# Article AMT-2020-78 – Response of Referee 2's comments

## Iteration #2

# Article AMT-2020-78 – Response of Referee 3's comments

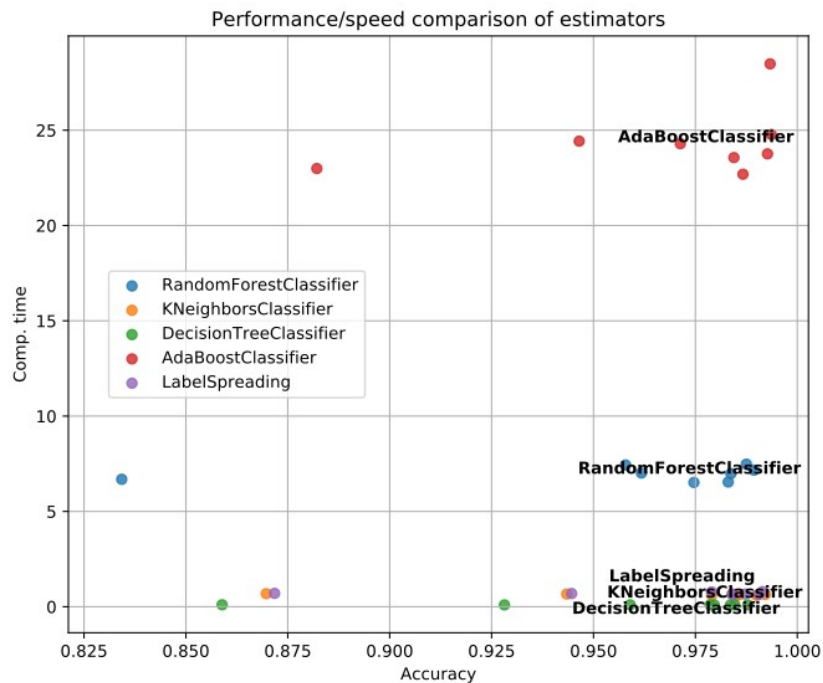
10. The KABL flowchart needs to be shown as a pseudo-code. The reviewer is also wondering, why the flowchart was made only for KABL, not for AdaBoost algorithm. If the paper attempts to compare both algorithms. They should be described fairly.

The Figure 6 was modified to highlight the common steps between KABL and ADABL (all but apply\_algo). As suggested, a pseudo-code was added in stead of the “Data” information. In the pseudo-code, we focused on the parameters of KABL because they are subject to a sensitivity analysis in the Sect. 4.1. The many abbreviations were also precised in the caption.

CC: new Figure 6
